**REMARKS**

Claims 1-6 are pending and Claims 1-6 have been objected to and rejected. In this amendment, Claims 1-6, the specification, the title, and the Abstract have been amended. No new matter has been added.

Fig. 6

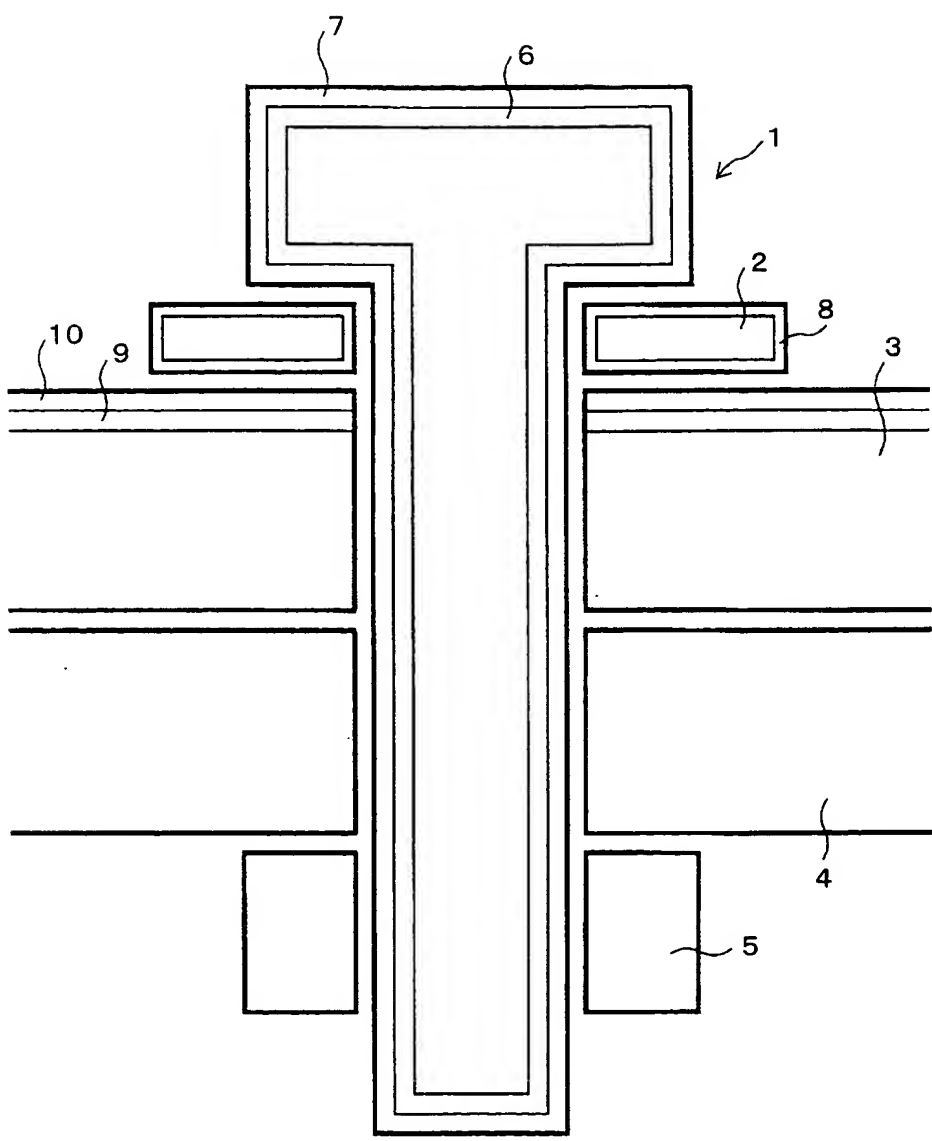
The drawings have been objected to under 37 CFR 1.83(a) as not illustrating every feature of the invention specified in the claims. Applicants have attached to this Response

a Proposed Figure 6 for the Examiner's consideration. It is submitted that Figure 6 illustrates all of the features of the claimed invention. In Fig. 6, a bolt 1 fixes a magnesium alloy member 3 and a magnesium alloy or heterogeneous material member 4 with a nut 5 through a washer 2. The bolt 1 is plated by zinc-nickel and then is treated with Cosmer chromating solution. Therefore, a zinc-nickel plating layer 6 and a Cosmer treatment layer 7 are provided on the surface of the bolt 1 in this order. The washer 2 is made of aluminum and is subjected to an alumite treatment, thereby providing an alumite-treated layer 8 on the surface of the aluminum washer 2. The magnesium alloy member 3 is electrodeposited by cationic electrodeposition and then is powder-coated on a surface faced to a head of the bolt 1. Therefore, an electrodeposition coating 9 and a powder coating 10 are provided on the surface in this order. It is requested that the objection be withdrawn.

A7 Fig. 6 shows an embodiment of the present invention, including a bolt structure (1), a magnesium alloy member or heterogeneous material member (4), a nut (5), a cationic electrodeposition coating (9), a powder coating (10), aluminum washer (2), a magnesium alloy member (3), an alumite-treated layer (8), zinc-nickel plating layer (6) and the cosmer treatment layer (7).
